Agenda Report

SUBJECT: PREDEVELOPMENT PLAN REVIEW FOR THE PROPOSED "MADRE VILLA ESTATES" SUBDIVISION AND DEVELOPMENT OF TWENTY-EIGHT SINGLE FAMILY PARCELS AT 800 SIERRA MADRE VILLA AVENUE (PPR2004-00024).

PREDEVELOPMENT PLAN REVIEW COMMENTS

Project Number: PPR2004-00024 **Date:** August 11, 2004

VESTING TENTATIVE TRACT MAP NO.

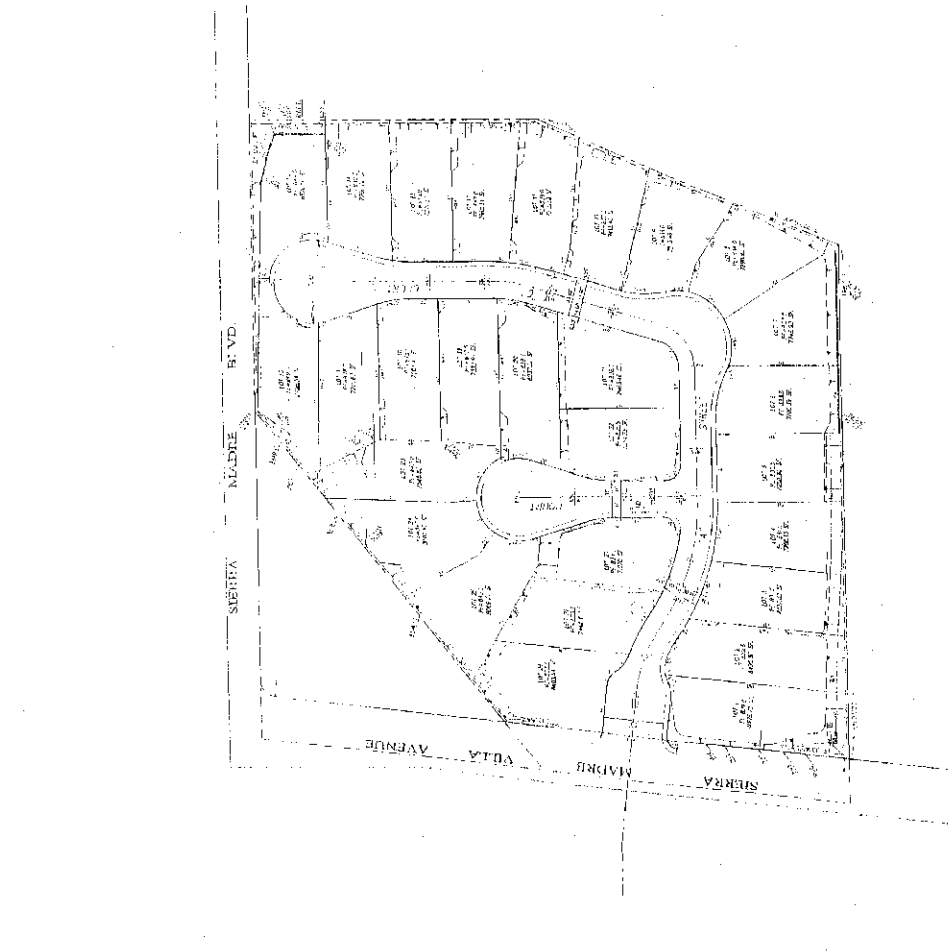
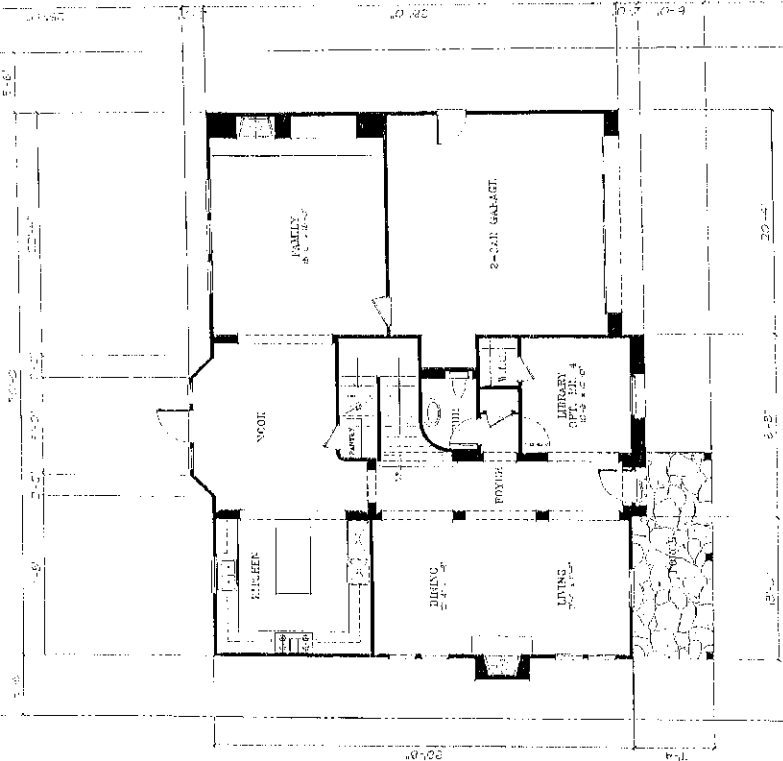
Minimum Lot Width: The minimum lot width in the RS-6 Zoning District is fifty-five (55) feet. For this particular case the lot width measurement is taken 25 feet back from the front property line. All parcels seem to be meeting the minimum lot width, the only parcel in question is lot number 12, please double-check this.

General Notes and questions: Lot "20" which will be considered a through lot, which contains two front yards, please be aware of development restrictions regarding fence height and the placement of accessory structures.

- Are the proposed streets private?
- Who is going to maintain the strip of land parallel to Sierra Madre Blvd? Will it be landscaped?
- Will there be an HOA?
- Would the developer consider sidewalks and parkways?

Drainage along the south property line shall be collected and conveyed to Sierra
